Subject: FW: Internal Consultation - App ref HGY/2022/2581

Subject: RE: Internal Consultation - App ref HGY/2022/2581

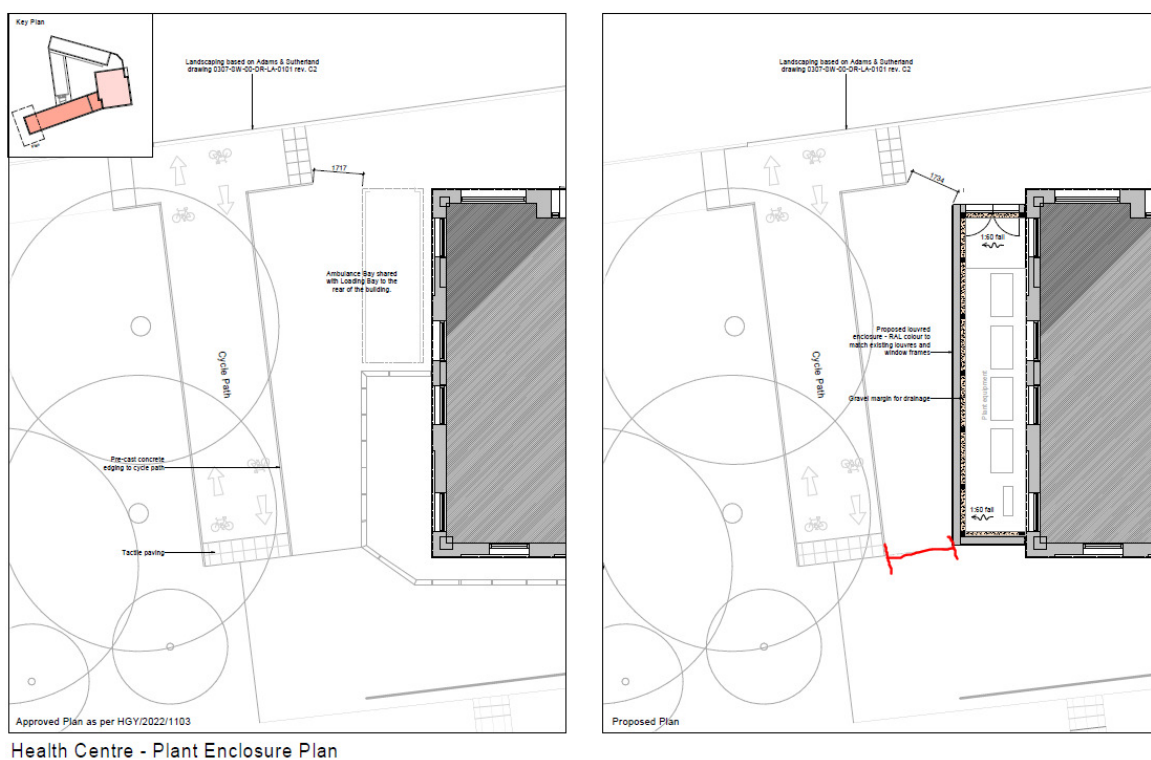
We have reviewed this application and are happy with this from a highway perspective. We welcome the change to the doors of the enclosure with them now opening out onto Chesnut Road rather than onto the footway/ cycleway. We would request that the width highlighted on the below is included on the plan for confirmation that this meets highway footway width requirements but we think it does.
